OPEN Letter - To whom it may concern:

The Mill Hill Neighbourhood Forum's Committee of local Mill Hill & Hale Ward residents has considered this major application carefully and now writes to oppose it on the following grounds:

Table 3.7 - Height & Density Ranges

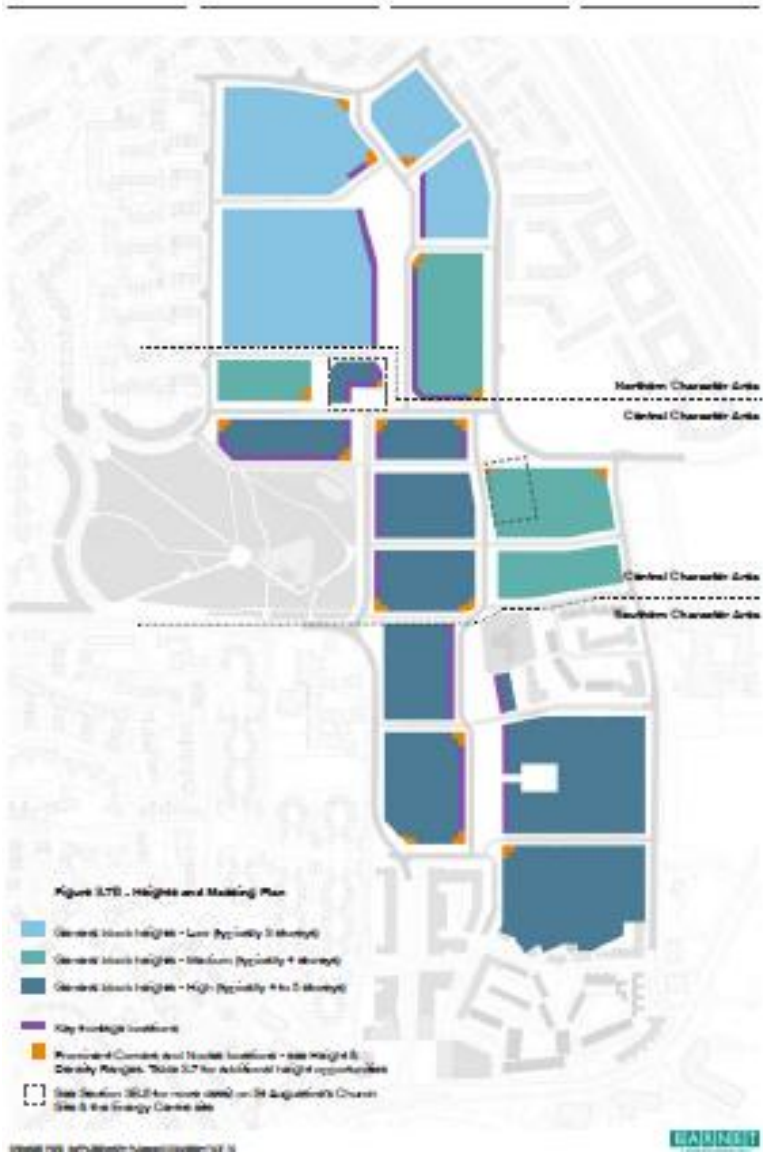
⊗
 Pentavia is here on the “wrong side of the tracks”.

The height and mass of the proposed development of Pentavia would completely over shadow the Northern Character Area of Grahame Park Estate, and the new properties in Churchill Place, Bunns Lane next to the Bright Little Stars nursery, together with the older houses in Bunns Lane, Brancaster Drive, and Longfield Avenue on the other side of the A1/A41.
